# CITY OF ALBUQUERQUE

**RE: Smiles for Kids Dental Office – Site Expansion**  
**Conceptual Grading and Drainage Plan**  
**Stamp Date: 03/07/18**  
**Hydrology File: C12D056**

Based upon the information provided in your resubmittal received 03/07/2018, the Conceptual Grading and Drainage Plan is approved for action by the DRB on the Site Plan for Building Permit.

project title	Smiles for Kids Dental Office - Site Expansion
sheet title	CONCEPTUAL GRADING & DRAINAGE PLAN
project address	9201 Eagle Ranch Road NW Albuquerque, New Mexico 87114

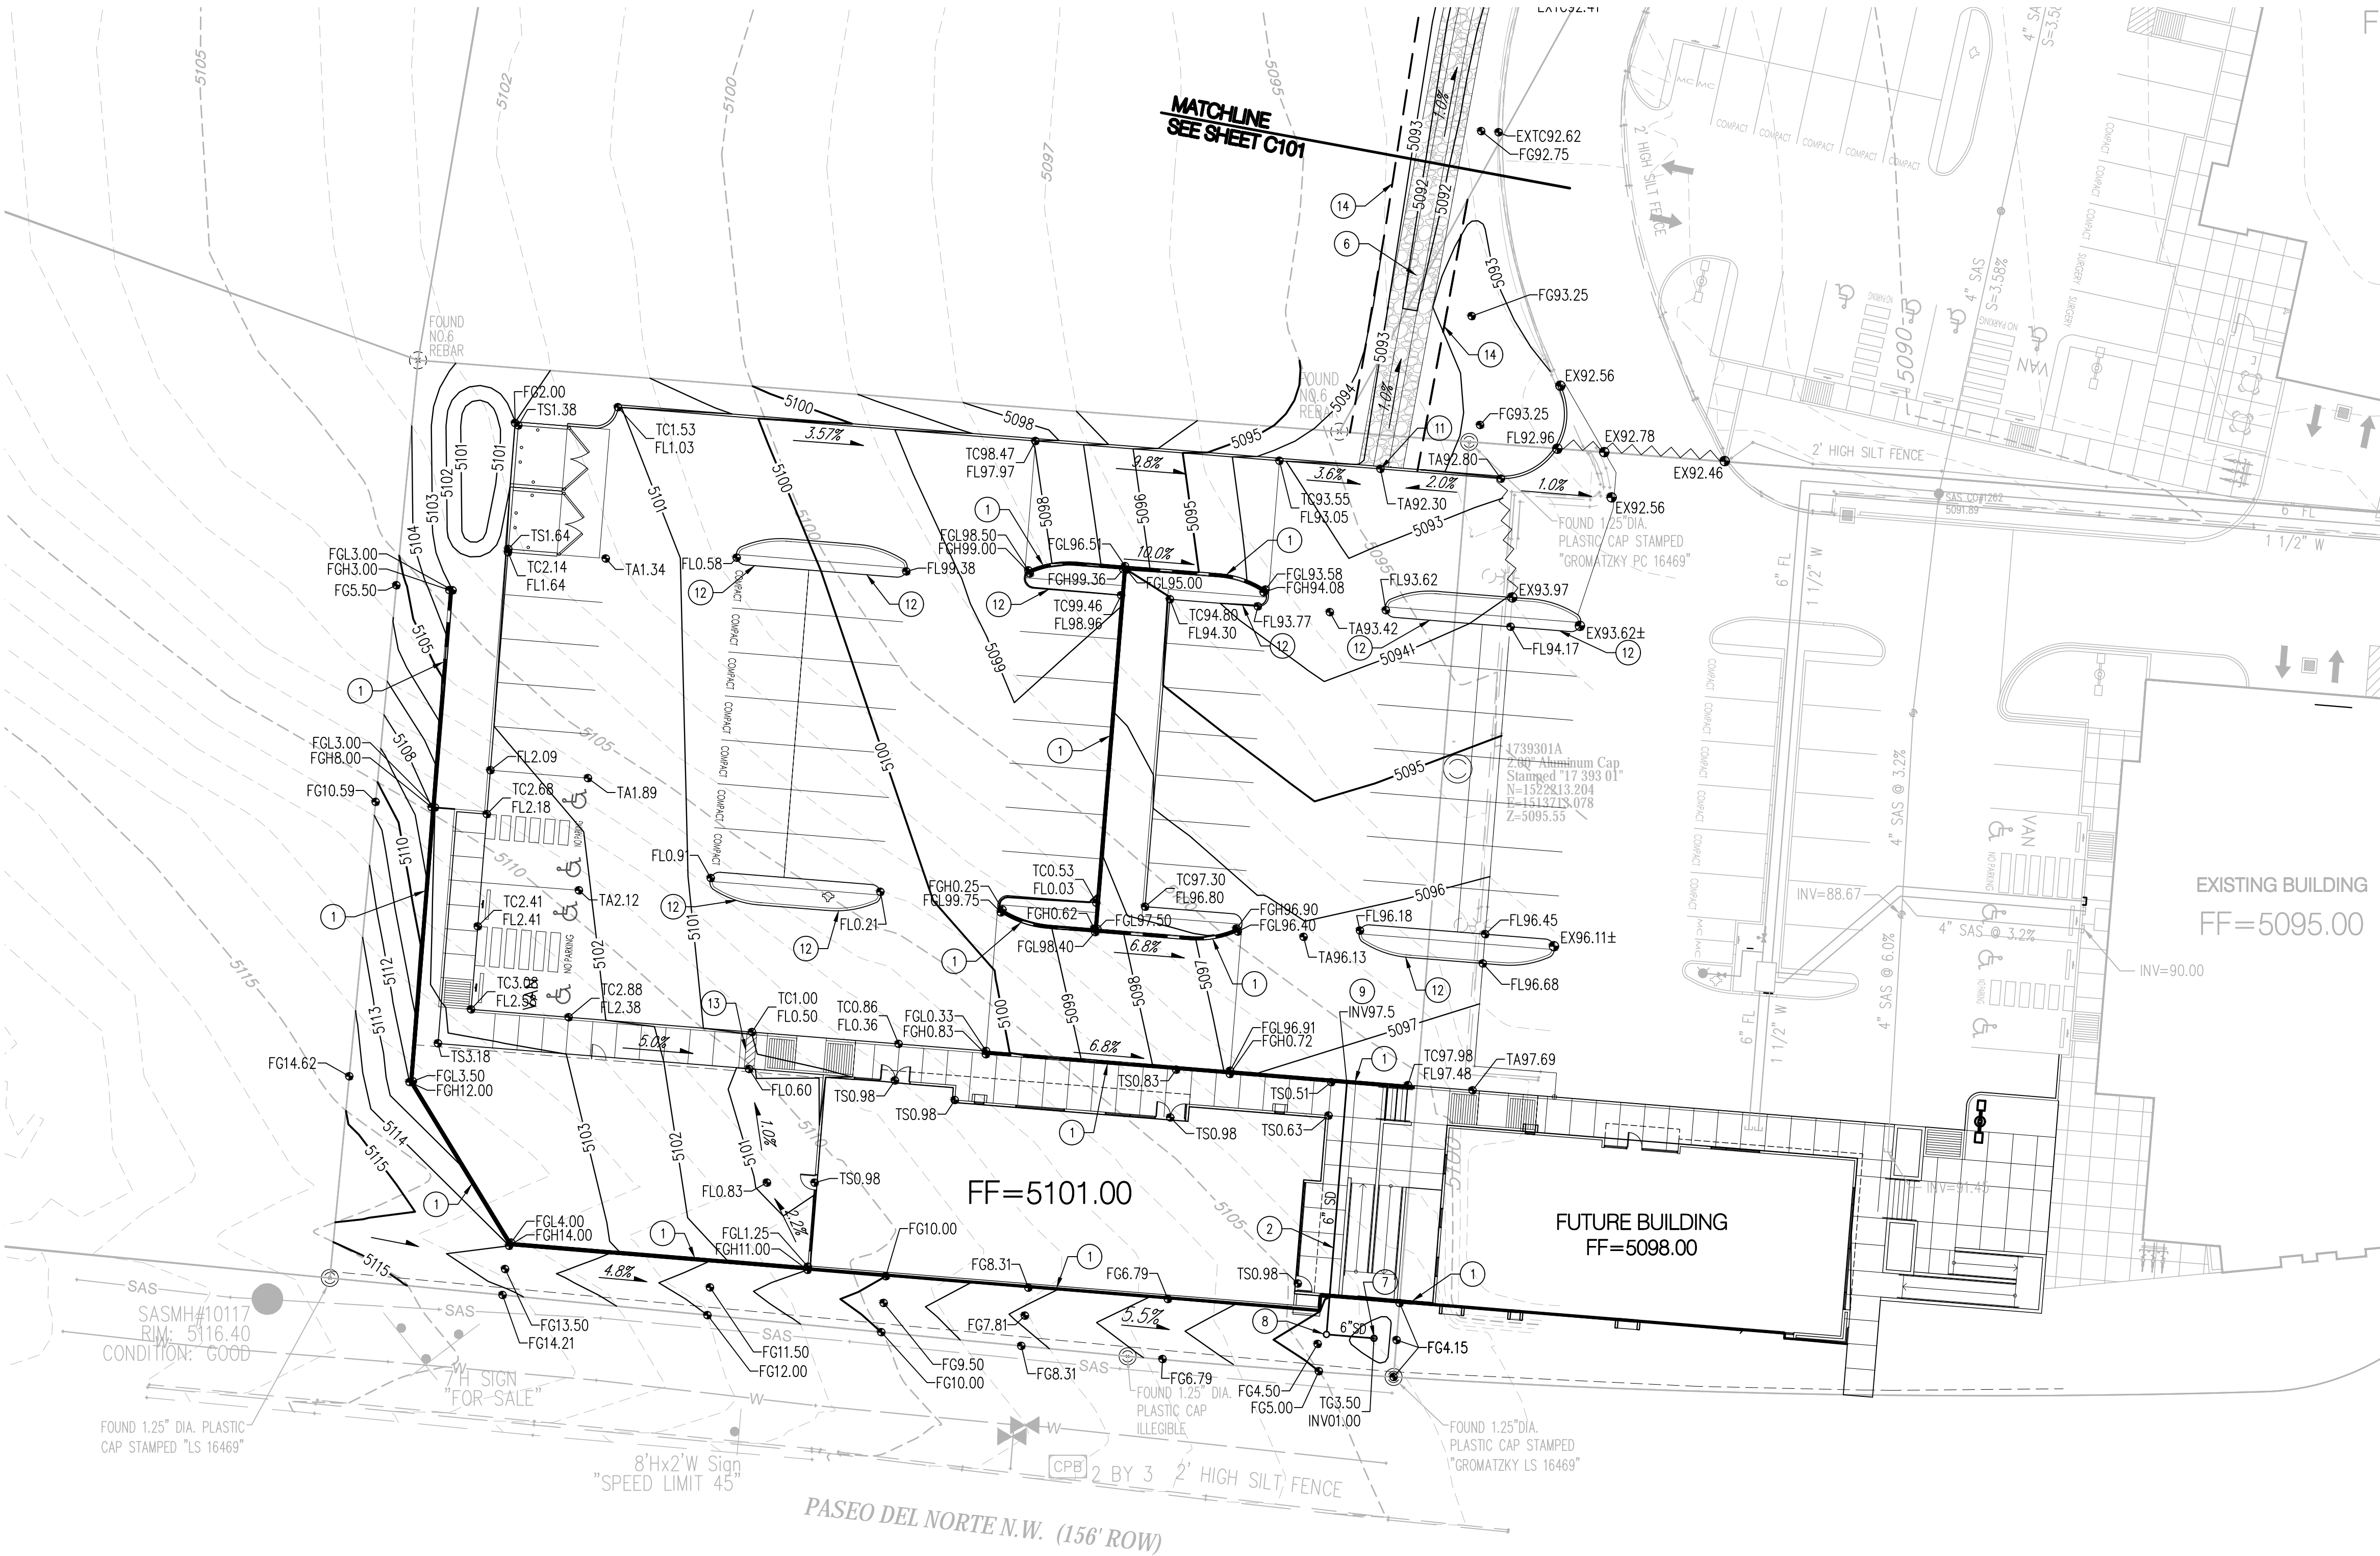
As a reminder, prior to obtaining Building Permit approval, please provide a written agreement from Tract F property Owner stating that grading can be conducted on their property for the benefit of Tract H. Also please provide a Private Facility Drainage Covenant for the on-site first flush ponds on Tract H, an Agreement and Covenant for the detention pond on Tract F and a Drainage Covenant for the private storm drain and drainage swales on Tract F. I have attached word documents of these for your use. After the drainage easement is recorded, please place a note stating the recording information on the Grading Plan.
